Fire Safety Report V 4 20.11.22
The National Trust
Erddig Hall, Wrexham

Author: Steve Emery CMIFireE
Heritage Fire Consultancy Limited

24th October 2022

This report, commissioned by Fleur Gordon, Senior Surveyor for the National Trust, details the existing fire performance of Erddig Hall, Stable Yard, Outer Yard, Lime Yard and ancillary buildings and makes recommendations for improvement. These recommendations are aimed at reducing the risk of fire spread to ensure the safety of visitors, staff, contractors, and the house with contents. The National Trust fire risk assessment dated 10.01.22 has been considered and are referenced in the door schedule as they arise.

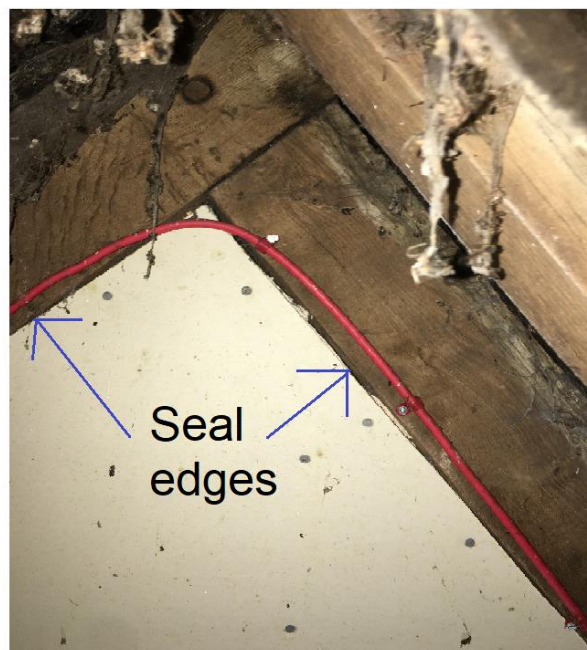
The compartmentation within the central roof void is generally very good with either brick-built partitions or fire-line boards on roof trusses, as shown in red and lettered for identification below. The main issues which should be addressed are shown on the plan below and in the following paragraphs.

- 1.1. Barrier B** should be sealed around the top edges with an intumescent mastic.

Adjacent to the South side of partition B, the underside of the plasterboard has not been sealed. This should be filled with compressed mineral wool. This also applies to other barriers with similar holes.

- 1.2. Partition D** is around the staircase and is one of the more critical protective barriers because the underside of the stair and the door at the base of the stair provides insufficient fire protection.

Barrier D lath and plaster

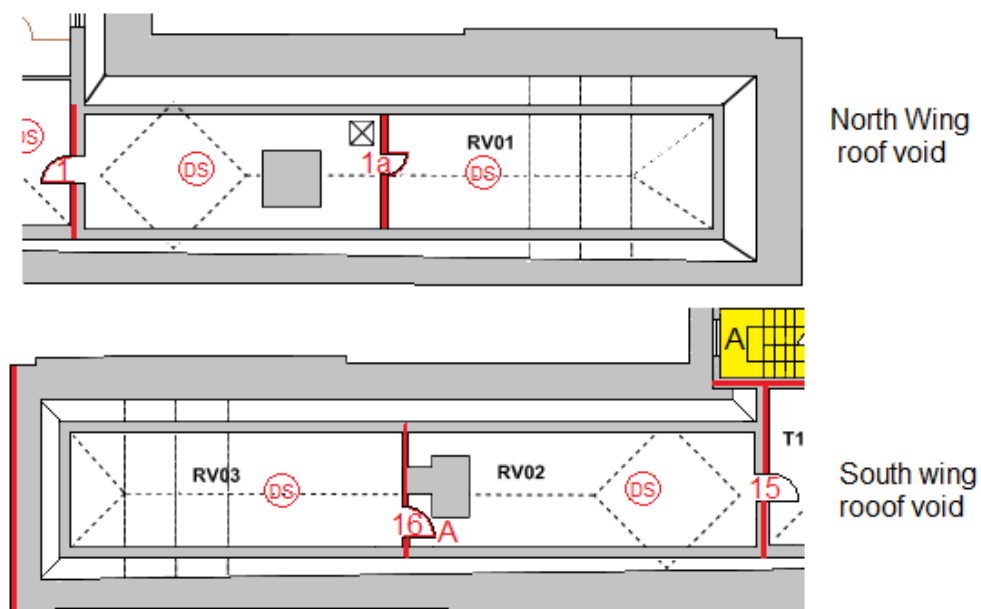
South of the barrier has a mixture of lath and lime plaster and plasterboard. The laths are a bit too close together at mid-height, so the plaster is not keyed sufficiently, and is likely to fail if attacked by fire. If the fire were already in the loft, the laths would burn rapidly, and the partition would also fail.

The keying of the plaster is fine at the top and bottom of the partition, where the laths are wide enough for the plaster to be pushed through but is not satisfactory mid-level at the height of the door handle.

The hole at the bottom right-hand side of the partition is beneath the steps leading up to the external door to the roof valley.

- a) Fill between the timber frame with 50mm Ablative Rockwool batts, sealed around the edges with intumescent mastic; or
- b) Provide a lath and 25mm lime plaster skin on this side of the partition. The edge of the door frame is in the way of the timber, so it would need an additional baton attached to the upright for fixing the laths; or
- c) Provide fire-line board to this side of the partition, which would also need a baton attached to the upright behind the door frame.

The hole at the base of the right-hand side should either be sealed with an ablative Rockwool batt or stuffed with compressed mineral wool. This should also be applied to same hole on the North side of the steps.

The hole at the apex of this partition should be effectively fire stopped with an intumescent mastic.

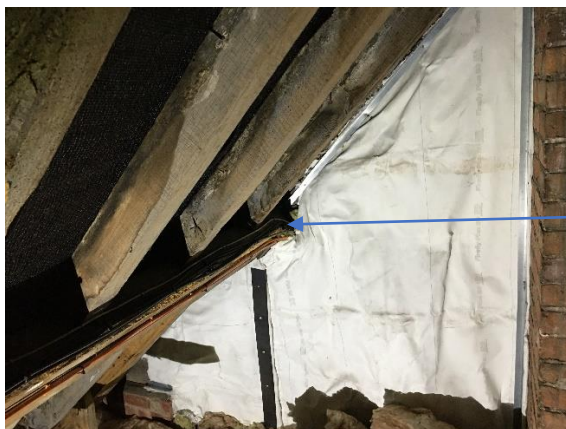
The top leaf is damaging the edge of the fireline board on the bottom leaf when opening the hatch. I recommend it is protected with a thin baton of wood about 10mm thick and 25mm wide screwed to the face of the fireline board level with the top.

Plan showing Stable Yard and Kitchen fire compartments in red

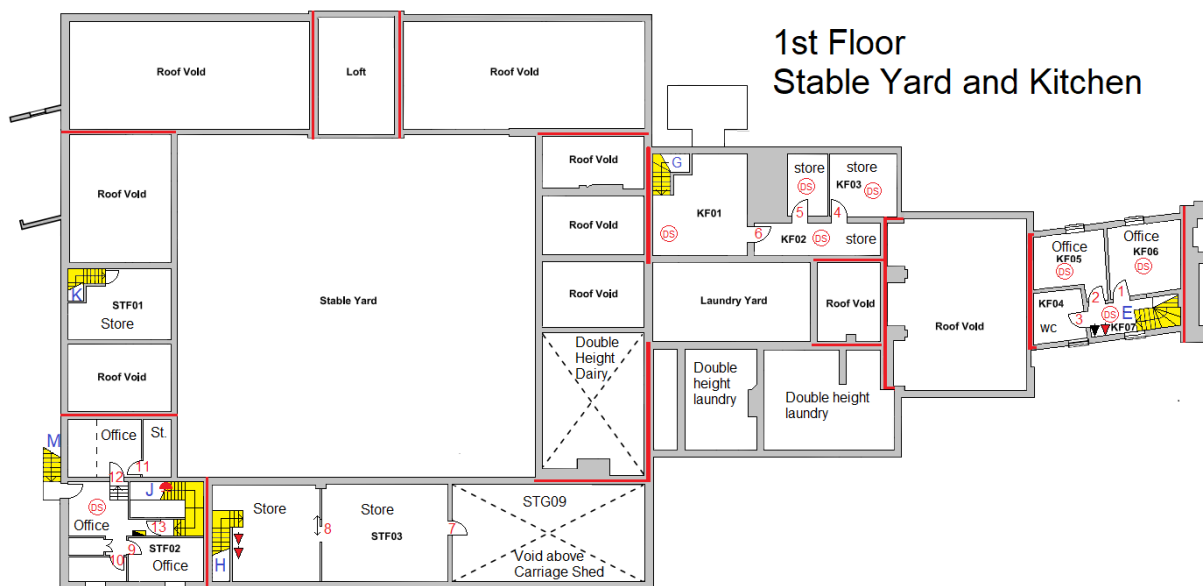
The Old Kitchen roof void was not accessible during my visit, but from external views it is very unlikely it connects with any other roof void. The East and West elevations aren't connected to any other part of the buildings. The North elevation has a gable end which is higher than the adjacent office KF05 and WC KF03. The Roof void above the offices KS05 were inspected and there's no evidence they were linked to the old kitchen roof void.

It would be reasonable to assume the roofs are fire separated in the locations shown below in red lines; either because the roof line can be seen internally in double height rooms and stables, or accommodation has been inserted into the roof as seen in the Southeast corner.

The largest compartment is store STF03 which is divided by a flimsy partition with a lightweight sliding door STF8 and is also connected by door STF7 to the void above the carriage shed. Fortunately, stair H is only accessible from outside the building so is fire separated from the rest of the building. As the Carriage shed and store STF03, which is mainly used for agricultural implements have very low fire loads, it would be practical to keep this area STF03 and SRG09 as a single fire compartment.

Plan of the first-floor Outer yard with fire resistance shown in red

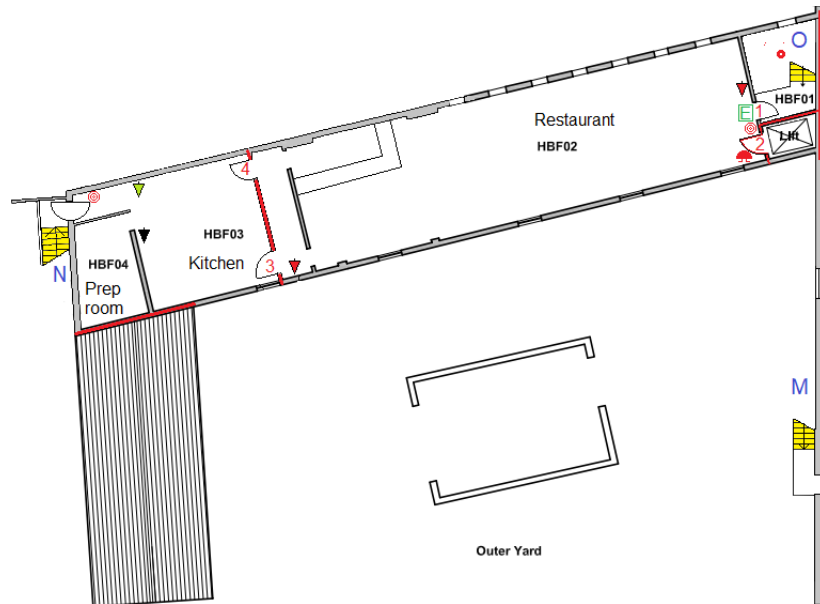
The outer yard only has the first-floor cafe and cafe kitchen which extend up into the roof and the junction with the stable yard can be seen within staircase O. Therefore has satisfactory fire separation. The kitchen and prep room adjoin the South wing which contains cart sheds and storage with adequate fire separation between the two.

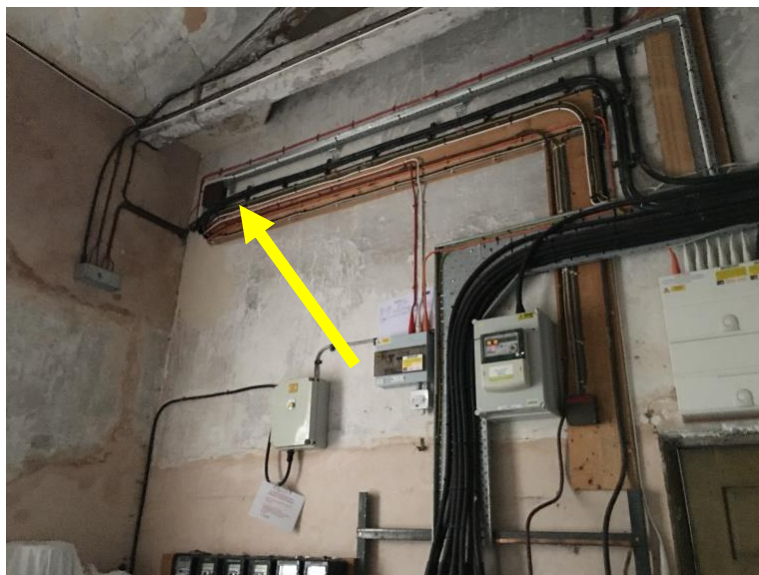
The fire exit to West of the property is via an inward opening door to the external grand stone staircase. The door is in a poor condition and sticks on the frame and threshold. At the time of my visit, the door was so tight the room steward trying to open it thought it was locked. When it was eased open it caught on the knob of the right-hand shutter. The shutter did not close properly because of the security bars that are kept there.

- a) the door is overhauled and
- b) The loose joints are cleaned up and re-glued
- c) The security bars are located elsewhere or are hung so that the shutter fully closes.

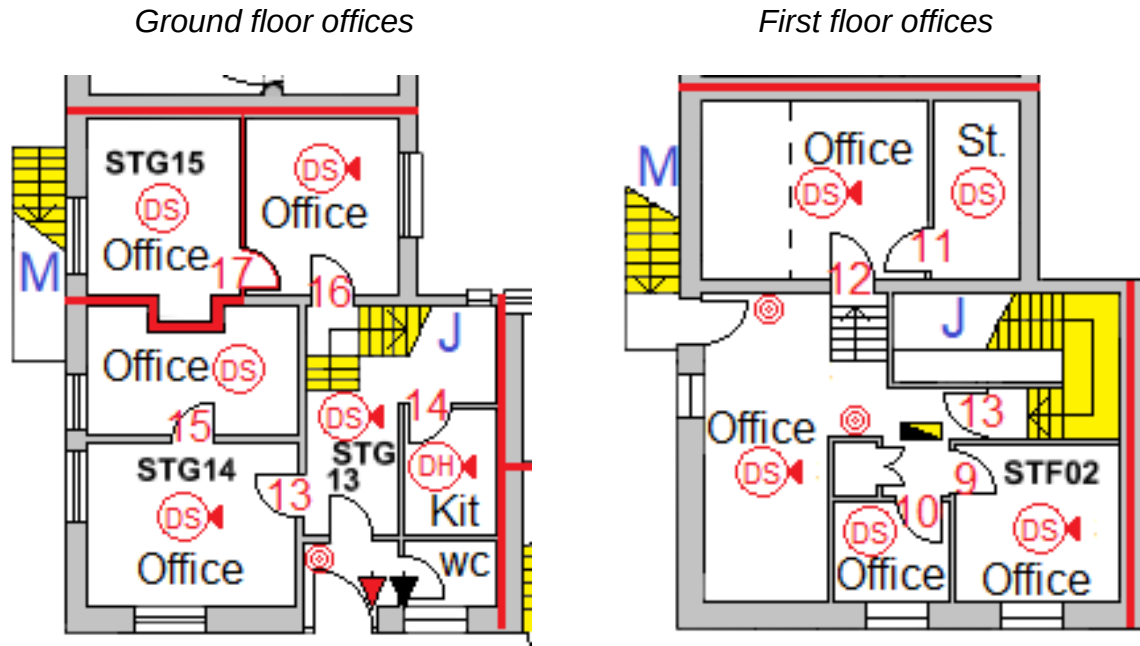
The Old kitchen was designed and built a safe distance from the mansion to prevent fire spread. It's linked by a corridor, but very unlikely a fire would spread to the mansion because of the proposed new fire door next to door 22. The glazed door to the kitchen doesn't need to be fire resisting as its scale and very low fire loading makes it impossible for a fire to reach flashover.

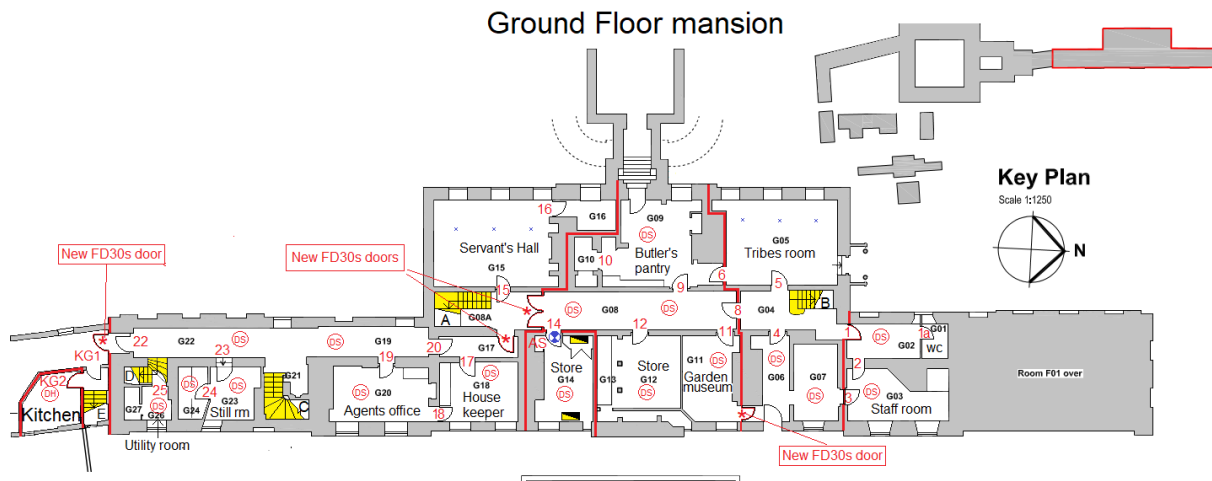
- a) Between the Ground floor Garden Museum room G11 and the passage G06. This would create a fire compartment from East to West along the line of the two chimneys, to include doors G6 and G8. This is also a recommendation of the fire risk assessment of January 2022.
- b) More controversial is a new set of double doors across the ground floor main passage G08 to create another compartment line from East to West, also in line with the chimneys. This would allow the door G14 to the electrical intake room, to remain as existing together with Doors G11 and G12, with their ventilation holes.
- c) Between staircase A and corridor G17. This would allow the doors G17, G19 and G20 to remain as existing.
- d) To the South of the original external door G22 all as shown on the plan on the next page marked with red asterisks.

These four sets of doors will protect and fire separate both main staircases and isolate the main house from the Kitchen and Stable yard. If they are not provided doors 10, 17, 14, 12 and 9 will need to be upgraded to FD30s self-closing standard.

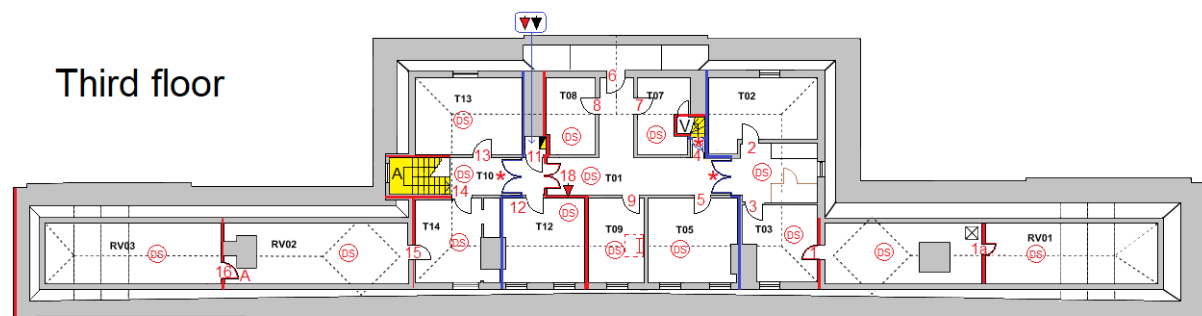
The other locations are across the 3rd floor corridor as shown in blue on the plan below and inside the staircase enclosure to the attic. The first set of new cross-corridor doors to the South will protect the third floor from a fire occurring elsewhere in the building and the second set to the North will separate divide the corridor in two to reduce the size of a fire which could start there.
